STATE OF WASHINGTON
DEPARTMENT OF LABOR & INDUSTRIES
ELEVATOR PROGRAM
PO Box 44480 OLYMPIA, WA 98504

I am asking that the revisions proposed in WAC 51-54A-8000 be revised to reinstate this NFPA 13-2019 requirement noted as (except 9.3.6.3(5)).

9.3.6.1* Sidewall spray sprinklers shall be installed at the bottom of each elevator hoistway not more than 2 ft (600 mm) above the floor of the pit.

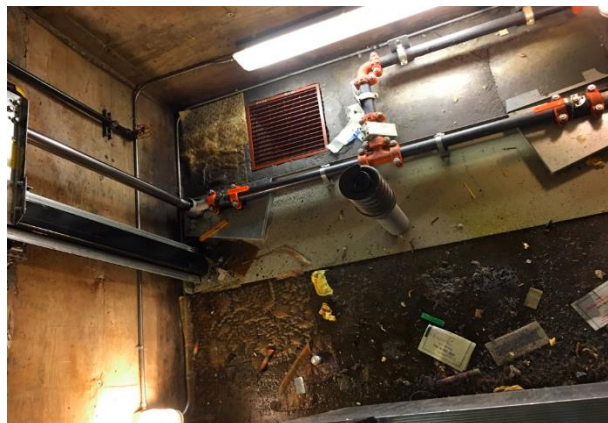
NFPA Flammability rating for Elevator hydraulic oil is given a 1(one). What this means is that elevator hydraulic fluid is actually flammable if it's heated up. What the concern is if a dirty elevator pit debris or paper records in the machine room catch fire, the exposed film of oil will heat up and cause the oil to burn. In an enclosed elevator hoistway the riding public is standing on a plywood floor and inside a ventilated cab that would allow toxic smoke to fill their lungs. The elevator pits are constantly accumulating paper and other flammable debris. The elevator service techs are only there quarterly or semiannually to service the equipment and check the pits. Hydraulic elevator pistons that move the car require a slight film of hydraulic oil to move freely. Each trip leaves more oil that goes into a catch container in the pit. Typical elevator pits have a heavy film of oil that gathers on the pit floor along with oil saturated paper etc. I have photos of elevator pits with varying degrees of debris.

Elevator Pit Photos examples NEW, typical, bad, and worst. All dirty would burn!

I am asking that the revisions proposed in WAC 51-54A-8000 be revised to reinstate this NFPA 13-2019 requirement noted as (except 9.3.6.3(5)).
